# Access Compliance Report

## Public Rights-of-Way

Intersection ID: 10038802	Main Street: STEELE_CREEK_RD	Cross Street: N/A	Location: SW
ADA ID: 298348221B3F	Ramp Type: PerpDiag	Initial Pass/Fail: Fail	Overall Compliance: No
Severity Score: 46.25			
Codes/Mitigation Info/Possible Solution		Field Measurements/Component Compliance

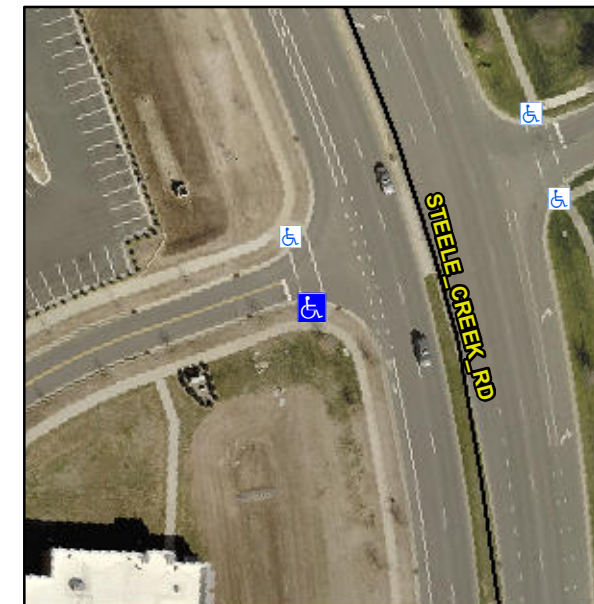
Compliance	Description	Data	Compliance	Description	Data
N/A	Ramp Length (in)	95.0	No	Ramp Slope (%)	8.7
No	Ramp Width (in)	47.5	No	Ramp XSlope (%)	7.9
N/A	Flare Type LT	N/A	N/A	Flare Type RT	N/A
N/A	Flare Slope LT (%)	N/A	N/A	Flare Slope RT (%)	N/A
N/A	Flare Traversable LT?	N/A	N/A	Flare Traversable RT?	N/A
N/A	Landing Length (in)	N/A	N/A	DWS Provided?	N/A
N/A	Landing Width (in)	N/A	N/A	DWS Contrast?	N/A
N/A	Landing Slope (%)	N/A	N/A	DWS Length (in)	N/A
N/A	Landing X Slope (%)	N/A	N/A	DWS Full Width?	N/A
N/A	Landing Curb? (Y/N)	N/A	N/A	DWS Offset (in)	N/A
N/A	Shared Landing?	N/A			
N/A	Gutter Ponding?	N/A	N/A	Gutter Slope (%)	N/A
N/A	Gutter Lip Ht (in)	N/A	N/A	Gutter X Slope (%)	N/A
N/A	Painted X Walk1?	No	N/A	Painted X Walk2?	Yes
	X Walk 1 Direction	To E		X Walk 2 Direction	To N
N/A	X Walk 1 Width (in)	N/A	N/A	X Walk 2 Width (in)	112.0
	X Walk 1 Slope (%)	4.2		X Walk 2 Slope (%)	1.1
	X Walk 1 X Slope (%)	1.5		X Walk 2 X Slope (%)	6.2

N/A	Ramp inside XWalk1?	N/A	N/A	Ramp inside XWalk2?	Yes
	Road Slope (%)	5.9	N/A	Clear Space?	N/A
	Road X Slope (%)	0.7	N/A	Clear Space to XWalk (in)	N/A
N/A	Any Obstructions?	N/A	N/A	Storm Grate/Utility Hazard?	N/A
	Obstruction Type			Storm Grate/Utility Type	
		N/A			N/A
		Yes		Surface Condition? (G/P)	Good

**Remove & Replace Curb Ramp With Two New Directional Ramps or Equivalent.**

**R304.5.1, R304.2.2, R304.5.3**
